GULFEAGLE SUPPLY - SITE PLAN LOTS 3-5, CLAREMONT BUSINESS PARK FILING NO. 2, 1455 SELIX GROVE, EL PASO COUNTY, COLORADO

SITE DEVELOPMENT PLAN

> MVE PROJECT 61078 MVE DRAWING -DEV-SP

MARCH 12, 2019 SHEET 1 OF 2

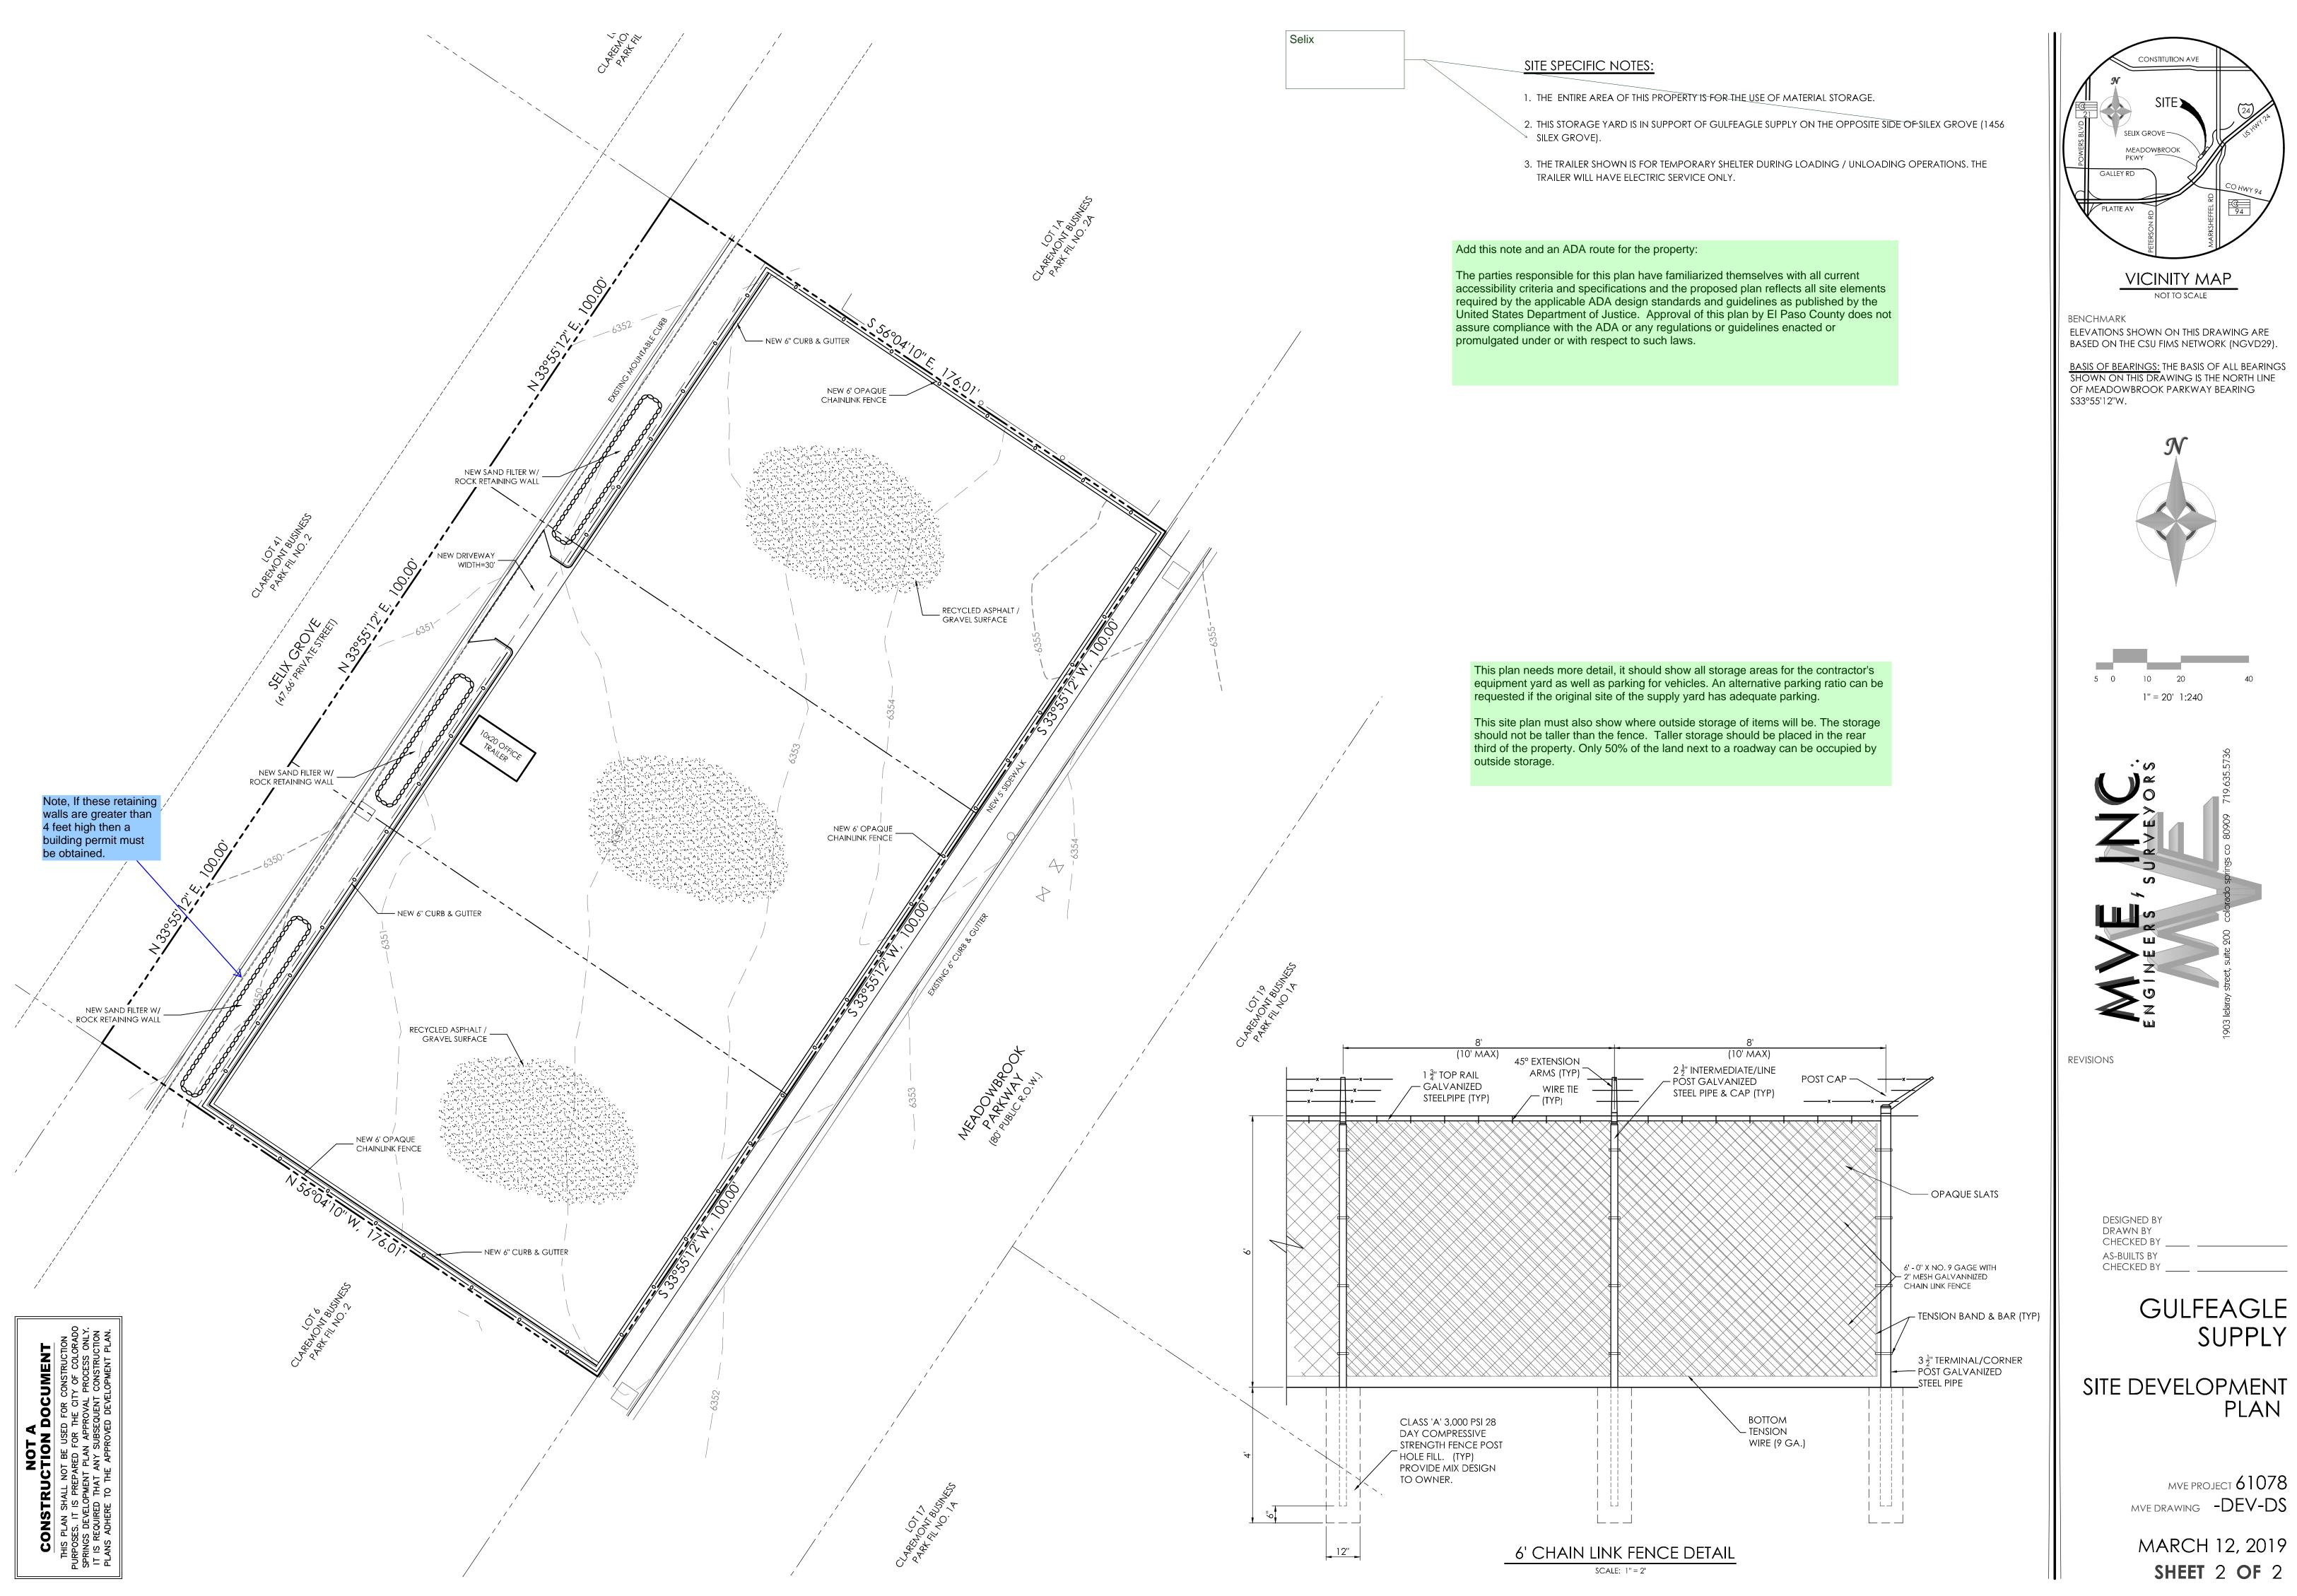
Add PCD File No. AL198 (1)

Add this note and an ADA route for the property: The parties responsible for this plan have familiarized themselves with all current

Change this to El Paso County or remove the note. (1)

Note, If these retaining walls are greater than 4 feet high then a building permit must be obtained. (1)

Selix (1)

Sidewalk will be required to be installed along Meadowbrook parkway. Show the proposed sidewalk and identify it as such. (1)

This plan needs more detail, it should show all storage areas for the contractor's equipment yard as well as parking for vehicles. Ar

This plan needs more detail, it should show all storage areas for the contractor's equipment yard as well as parking for vehicles. An alternative parking ratio can be requested if the original site of the supply yard has adequate parking.

This site plan must also show where outside storage of items will be. The storage should not be taller than the fence. Taller storage should be placed in the rear third of the property. Only 50% of the land next to a roadway can be occupied by outside storage.
